## TELEVISION TECHNICAL BULLETIN

<b><u>MODELS</u></b>	<b>56FW53H</b>	<b>66FW53H</b>	<b>66FW54H</b>	<b>76FW53H</b>
	<b>76FW54H</b>	<b>59ESD7H</b>	<b>66ESD7H</b>

### Faults experienced on the DA100 (50Hz) Chassis

**CRT Socket.**

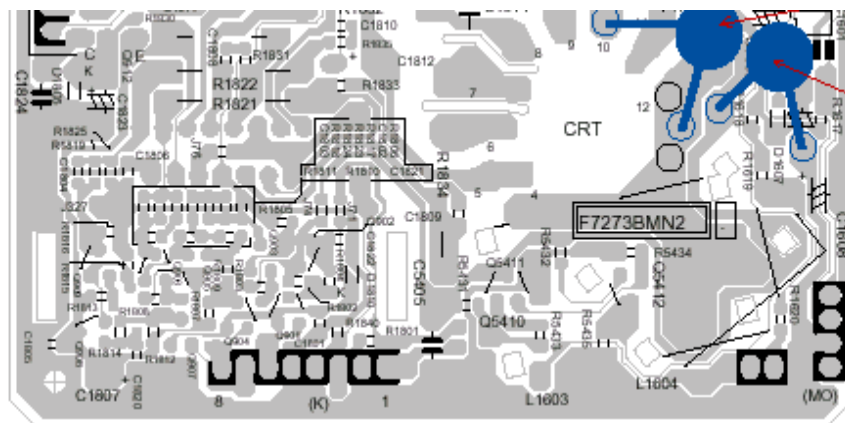
**SYMPTOM** NVM corruption.

**CAUSE** Arcing can occur on the CRT base panel (PWB-B) caused by CRT discharges.

**ACTION** Add capacitors C1826 and C1827 as shown in the picture below.

<u>REF NO</u>	<u>DESCRIPTION</u>	<u>PART NUMBER</u>	<u>PRICE CODE</u>
C1826	Ceramic capacitor 4.7nf 10% 500V	VCKYPA2HB472K	AB
C1827	Ceramic capacitor 10nf 20% 250V	RC-KZ0029CEZZ	AC

**C1826: Q5405 & Q5411 collectors track.**
